**RE: 26 Grenville Street and 27 Grosvenor Street – Site Plan Application (3rd Submission)
Response to City Comments**

Memorandum: Site Plan Application No: 19 127591 STE 13 SA Dated January 28, 2020; from Pat F. Scanga, P.Eng, Manager, Development Engineering – Toronto & East York to David Sit, Manager, Community Planning, Toronto & East York

SUBJECT: **Rezoning Application No.: 19 127586 STE 13 OZ and**
Site Plan Application No.: 19 127591 STE 13 SA
Your Circulation Memorandum Dated: December 3, 2020
Owner: Choice Grosvenor/Choice Properties REIT/ Grenville Inc.
Applicant: Greenwin Holdings Inc.
Location: 26 Grenville Street and 27 Grosvenor Street

Project: 27 GROSVENOR ST. Project No. 6004-07 Date: JUNE 2021 Revised: -	Scale: 1:750
Drawing No. SN-01A

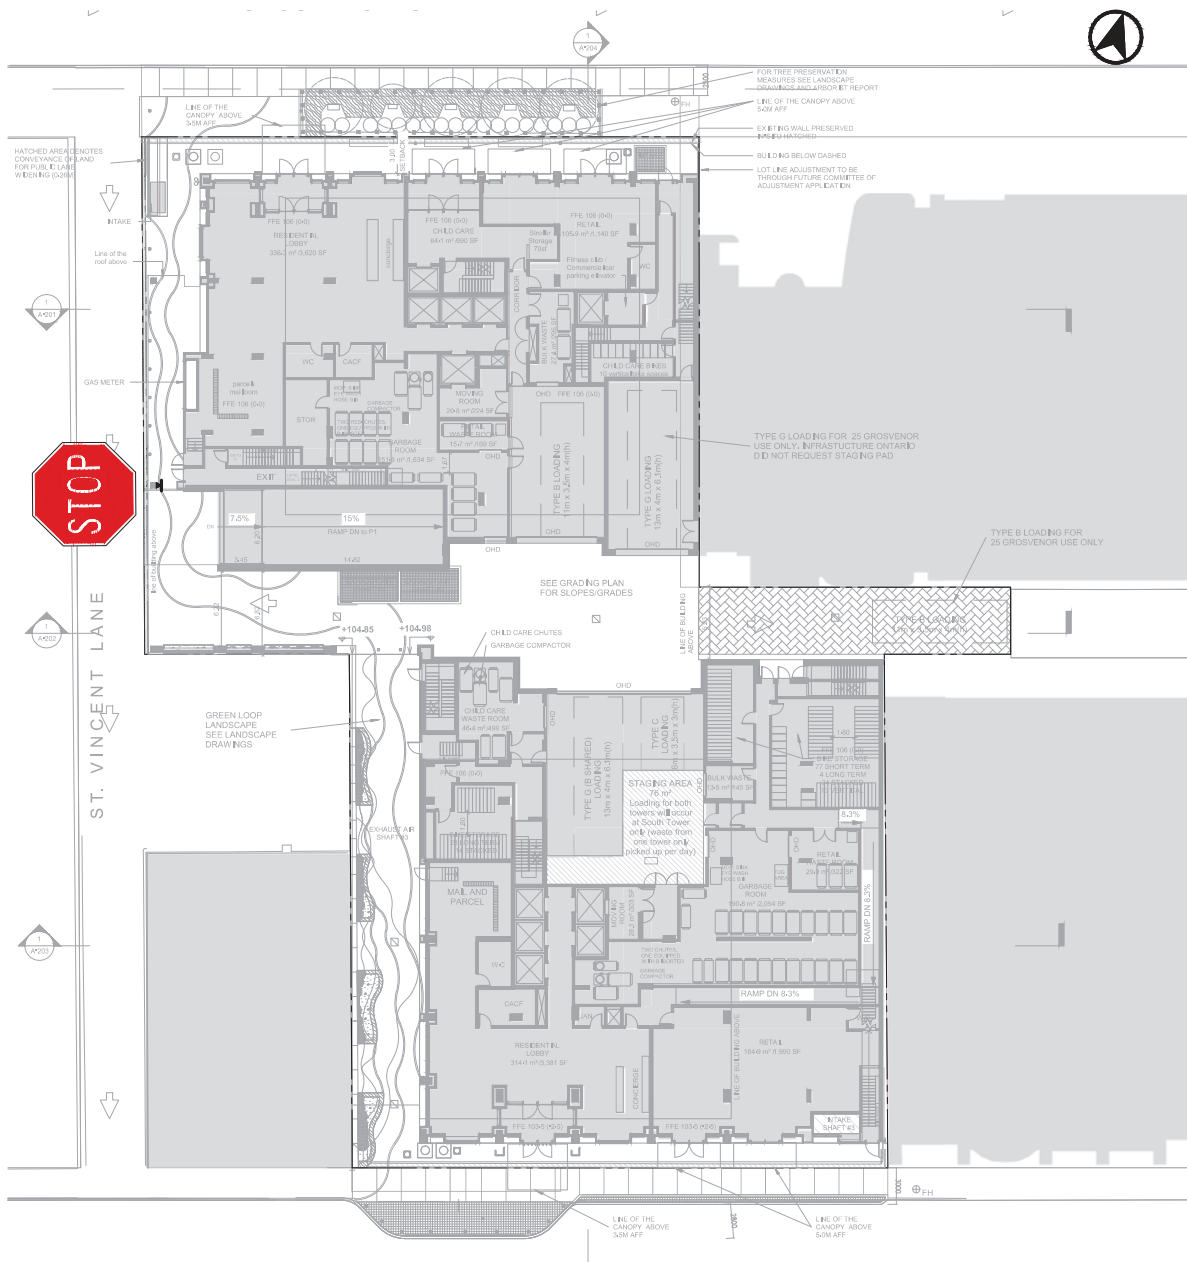
Revise the Signage Plan (Figure 2) of the Transportation Response Comments, dated November 13, 2020, prepared by BA Group, as discussed further in Section G Below.

The developer and Children's Services met on October 23rd and we discussed the lack of parking for the Child Care Centre. The drop-off & pick-up is located on the street and we stated that we need a minimum of 20 minutes posted on signs indicating that this is for DO & PU dedicated to the CCC. This sheet is showing 2 parking spaces dedicated to the CCC so I am not sure where they are located.

The proposed signage plan has been revised in consultation with City Transportation Services staff. The changes to the proposed traffic signage on Grosvenor Street and Grenville Street discussed with City Staff are summarized below.

Please refer the revised signage plan in **Appendix C** for more information.

Noted. Through discussions with Transportation Services and Children Services staff, it has been recommended that a dedicated 15 minute pick-up / drop-off zone is provided at-grade along Grosvenor Street and will accommodate 4 parking spaces dedicated to the child care. In addition, 6 parking spaces dedicated to child care, of which 4 are proposed to be dedicated for pick-up / drop-off activity, are proposed in the P1 level of the underground parking garage. Please refer to the reduced scale architectural plans in **Appendix A** for the locations of the child care spaces in the P1 level and the signage plan in **Appendix C** for the location of the proposed pick-up / drop-off zone along Grosvenor Street.
